Commonwealth Edison

Subject: Byron Station Units 1 and 2
Braidwood Station Units 1 and 2
Pipe Support Anchor Plates
NRC Docket Nos. 50-454, 50-455, 50-456
and 50-457

This is to provide advance copies of responses to FSAR questions regarding the flexibility of baseplates for pipe supports at Byron and Braidwood. This information will be included in the FSAR at the next amendment.

Plate No. 1
12x12x3/4 in
4 anchors 3/4"

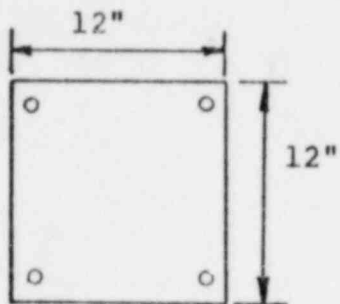
Examples of three expansion anchor plate assemblies are provided. The square plates are with four and eight anchors and the rectangular plate is with six anchors. The maximum applied load on the assemblies and the corresponding anchor forces obtained by the rigid plate analysis and the flexible plate analysis are tabulated. The amplification factors as defined in response to Question 110.71 are also tabulated. The larger of the computed amplification factors for each plate assembly is used as the design amplification factor.

<u>Plate No.</u>	<u>Anchor Assembly</u>	<u>Load</u>	<u>Max. Anchor Reaction (Flexible Plate Analysis)</u>	<u>Max. Anchor Reaction (Rigid Plate) Analysis)</u>	<u>Amplification Factor</u>
1	12x12x1/2 in 4 anchors 1/2"	33.6 k (tension)	8.4	8.4	1.0
		159.2 in-k (moment)	7.43	8.4	1.0
2	9x15x1/2 in 6 anchors 1/2"	33.7 k (tension)	7.0	5.62	1.25
		199 in-k (moment)	7.0	6.62	1.06
3	21x21x7/8 in 8 anchors 3/4"	114 k (tension)	16.0	14.25	1.12
		900 in-k (moment)	16.0	14.7	1.09
